Access Compliance Report

Public Rights-of-Way

(Curb Ramps)

Intersection ID: 5407	Main Street: J_W_CLAY_BV	Cross Street: J_M_KEYNES_DR	Location: W
ADA ID: BB08C8BB5D4A	Ramp Type: Perp	Initial Pass/Fail: Fail	Overall Compliance: No
		Severity Score: 25

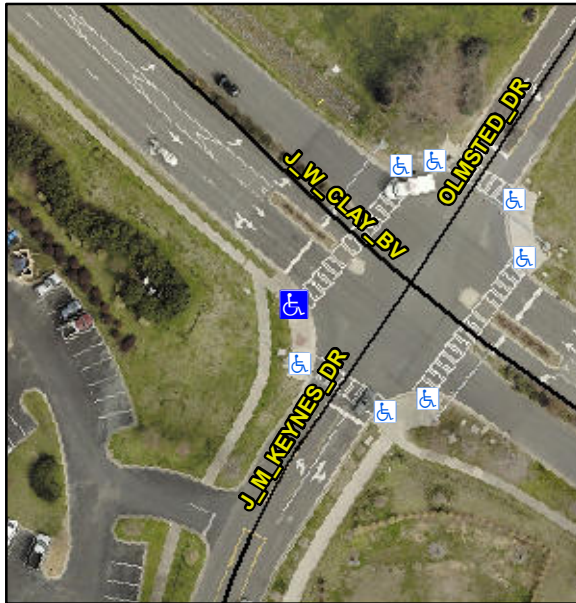
R304.2.2

Compliance	Description	Data	Compliance	Description	Data
N/A	Ramp Length (in)	62.0	No	Ramp Slope (%)	16.3
Yes	Ramp Width (in)	48.0	Yes	Ramp XSlope (%)	1.1
N/A	Flare Type LT	N/A	N/A	Flare Type RT	N/A
N/A	Flare Slope LT (%)	N/A	N/A	Flare Slope RT (%)	N/A
N/A	Flare Traversable LT?	N/A	N/A	Flare Traversable RT?	N/A
N/A	Landing Length (in)	N/A	N/A	DWS Provided?	N/A
N/A	Landing Width (in)	N/A	N/A	DWS Contrast?	N/A
N/A	Landing Slope (%)	N/A	N/A	DWS Length (in)	N/A
N/A	Landing X Slope (%)	N/A	N/A	DWS Full Width?	N/A
N/A	Landing Curb? (Y/N)	N/A	N/A	DWS Offset (in)	N/A
N/A	Shared Landing?	N/A			
N/A	Gutter Ponding?	Yes	N/A	Gutter Slope (%)	N/A
N/A	Gutter Lip Ht (in)	N/A	N/A	Gutter X Slope (%)	N/A
N/A	Painted X Walk1?	No	N/A	Painted X Walk2?	N/A
	X Walk 1 Direction	To NE		X Walk 2 Direction	N/A
N/A	X Walk 1 Width (in)	N/A	N/A	X Walk 2 Width (in)	N/A
	X Walk 1 Slope (%)	1.2		X Walk 2 Slope (%)	N/A
	X Walk 1 X Slope (%)	1.5		X Walk 2 X Slope (%)	N/A

Remove & Replace Entire Ramp.
